Access Compliance Report

Public Rights-of-Way

(Curb Ramps)

Intersection ID: 50633	Main Street: BLUE_BLOSSOM_RD	Cross Street: CORAL_ROSE_RD	Location: SE
ADA ID: 9B853D252DF1	Ramp Type: Perp	Initial Pass/Fail: Fail	Overall Compliance: No
Severity Score: 1.25			
Codes/Mitigation Info/Possible Solution		Field Measurements/Component Compliance

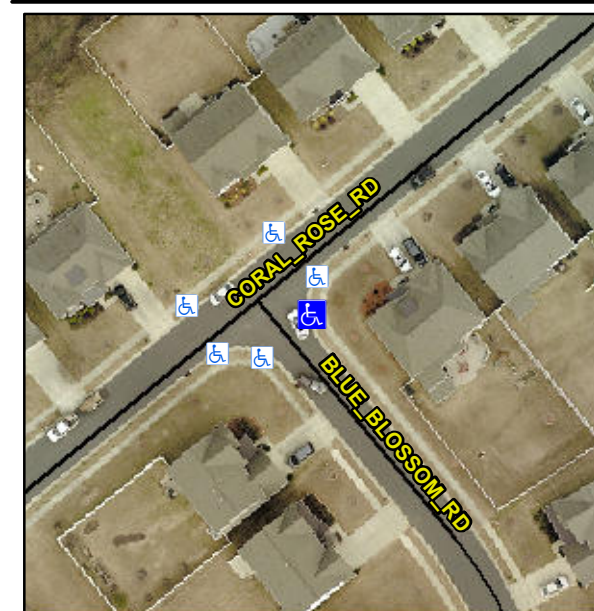
Not Found, R304.5.3

Compliance	Description	Data	Compliance	Description	Data
N/A	Ramp Length (in)	47.0	Yes	Ramp Slope (%)	7.4
Yes	Ramp Width (in)	48.0	No	Ramp XSlope (%)	4.5
N/A	Flare Type LT	N/A	N/A	Flare Type RT	N/A
N/A	Flare Slope LT (%)	N/A	N/A	Flare Slope RT (%)	N/A
N/A	Flare Traversable LT?	N/A	N/A	Flare Traversable RT?	N/A
N/A	Landing Length (in)	N/A	N/A	DWS Provided?	N/A
N/A	Landing Width (in)	N/A	N/A	DWS Contrast?	N/A
N/A	Landing Slope (%)	N/A	N/A	DWS Length (in)	N/A
N/A	Landing X Slope (%)	N/A	N/A	DWS Full Width?	N/A
N/A	Landing Curb? (Y/N)	N/A	N/A	DWS Offset (in)	N/A
N/A	Shared Landing?	N/A			
N/A	Gutter Ponding?	N/A	N/A	Gutter Slope (%)	N/A
N/A	Gutter Lip Ht (in)	N/A	N/A	Gutter X Slope (%)	N/A
N/A	Painted X Walk1?	No	N/A	Painted X Walk2?	N/A
	X Walk 1 Direction	To SW		X Walk 2 Direction	N/A
N/A	X Walk 1 Width (in)	N/A	N/A	X Walk 2 Width (in)	N/A
	X Walk 1 Slope (%)	0.9		X Walk 2 Slope (%)	N/A
	X Walk 1 X Slope (%)	4.0		X Walk 2 X Slope (%)	N/A

Remove & Replace Entire Ramp.
